PIC16F73/74/76/77 Rev. B1 Silicon/Data Sheet Errata

The PIC16F73/74/76/77 Rev. B1 parts you have received conform functionally to the Device Data Sheet (DS30325B), except for the anomalies described below.

FIGURE 1: CRYSTAL/CERAMIC RESONATOR OPERATION (HS, XT OR LP OSC CONFIGURATION)

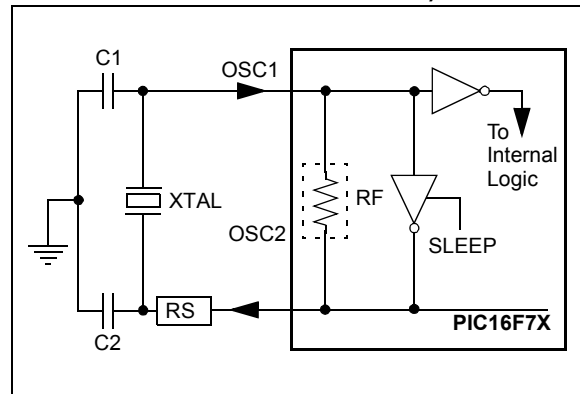
3. Module: Oscillator (HS mode)

When resonators above 2 MHz are used, the HS mode oscillator is required to ensure reliable operation. HS mode oscillator drive at frequencies from 2 MHz to 4 MHz is often excessive, resulting in the amplitude of the oscillator waveform exceeding V_{DD} and V_{SS} . In such cases, the waveform may experience distortion as ESD protection devices begin to operate on the OSC1 and OSC2 pins. This distortion appears as a non-sinusoidal waveform or clipping, and can generate substantial harmonics that may create excessive noise in the application.

The gain of the oscillator should be reduced by inserting a series resistance between the OSC2 pin and the resonator/capacitor as shown in the data sheet (see Figure 1). The value of the series resistance is dependant on V_{DD} , resonator frequency, and temperature; however, 330 ohms has been used as a good starting point for evaluation.

This change will not affect operation of future revisions of silicon as long as HS mode is selected.
